# Product Change Notification

**Change Notification #:** 116613 - 00  
**Change Title:** Intel® Server System R2208WTTYSR,  
PCN 116613-00,  
Product Design, Order Code,  
Rear panel and rear brackets new design  
**Date of Publication:** November 27, 2018

Image 2 Rear Panel after the change

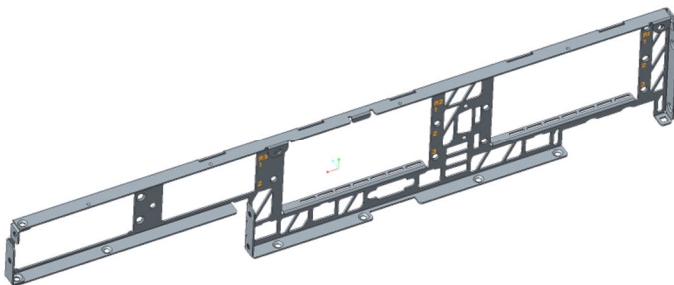
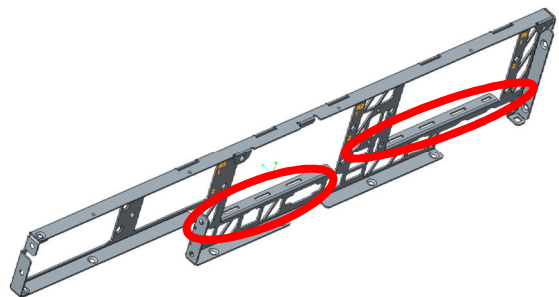
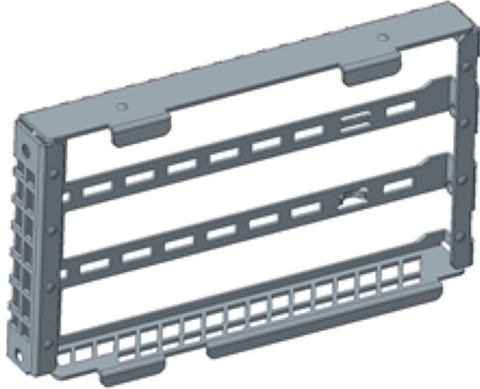
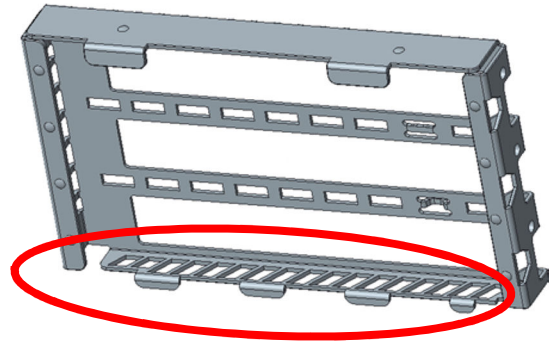
1. Adding holes to the rear panel.

*Image 4. Rear center bracket after the change*

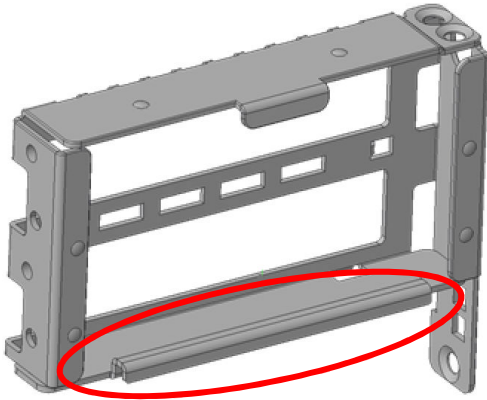
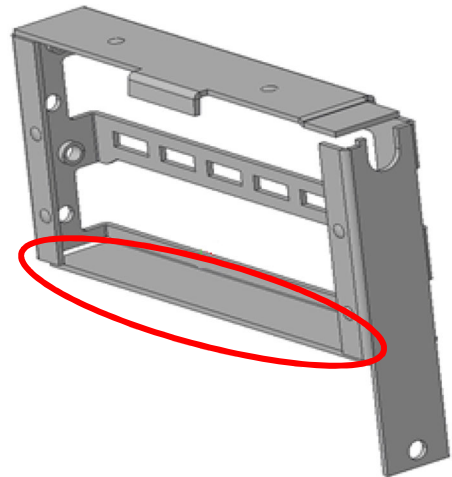
2. The center rear bracket has a new design

Image 8. 2U right riser bracket after the change

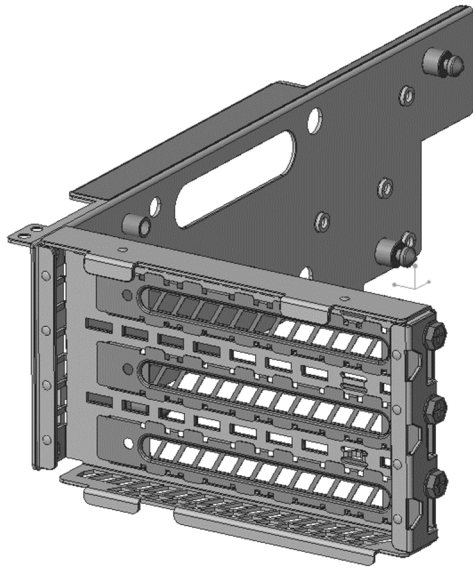
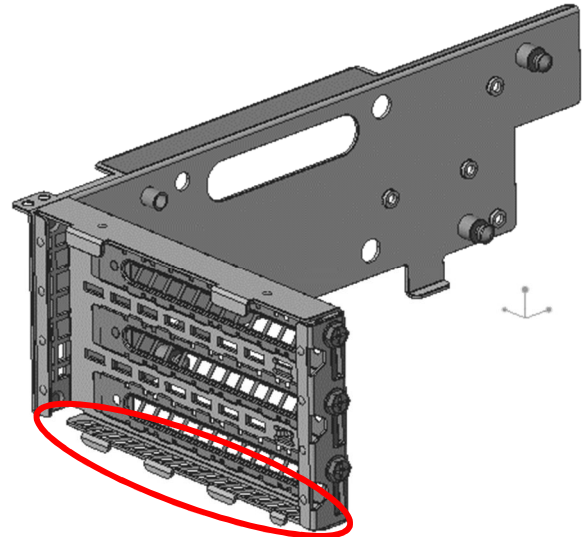
4. The right riser bracket has a new design.
